REMARKS

Application No. 10/731,420

Preliminary Amendment dated October 26, 2005

AMENDMENT TO THE FIGURES:

Fig. 1

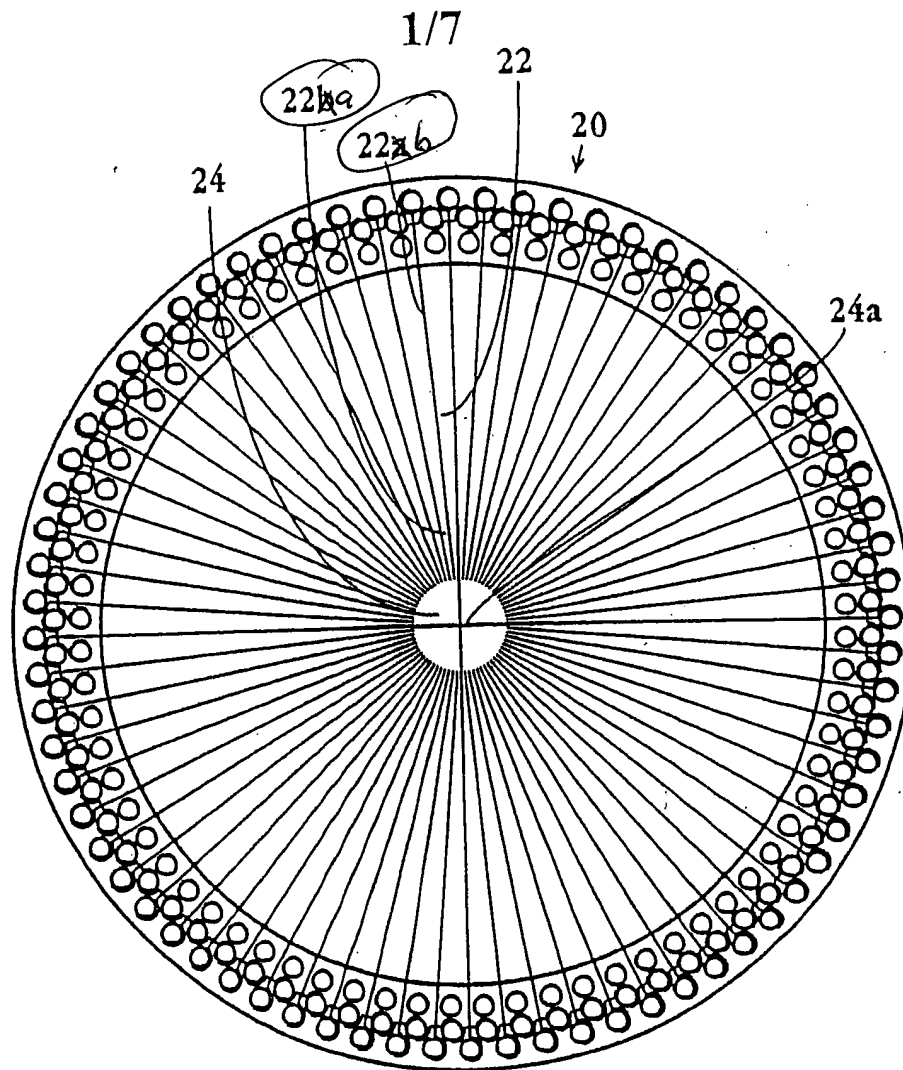
In order to correct inadvertent typographical errors, Applicants have amended Fig. 1 and Fig. 2. The amendment to the drawings changes the designation “22a” to “22b” and “22b” to “22a” in Fig. 1 and “22a” to “22” in Fig. 2. These changes should be recognized as obvious typographical errors by one of skill in the art looking at the figures in conjunction with the description in the specification. The changes make the specification consistent.

Support for the changes is as follows. Page 7, lines 20-23 recites that “The central reservoir region 24 . . . is in fluid communication with the proximal ends.” Thus, “22a” is the proximal end of microchannel 22. The specification further states at Page 7, lines 25-28, “In the embodiment shown in Fig. 3, each microchannel terminates at its **distal end** with three channels 26a, 26b. . .”. (emphasis added) The specification at page 7, lines 17-18 also recites, “Each microchannel includes a proximal end 22a and a distal end 22b. Therefore, in Fig. 1, the designation in the figure should be amended to show the proximal end as “22a” and the distal end as “22b.” Additionally, Applicants have removed the “a” from “22a” in Fig. 2 to be consistent with Fig. 1 and the specification.

The attached replacement sheet of drawings includes changes to Fig. 1 and Fig 2. The replacement sheet, which includes Figs. 1-3, replaces the original sheet including Figs. 1-3. Also attached is a copy of the original drawing sheet showing annotations in red ink that result in the changes incorporated in the replacement sheet.
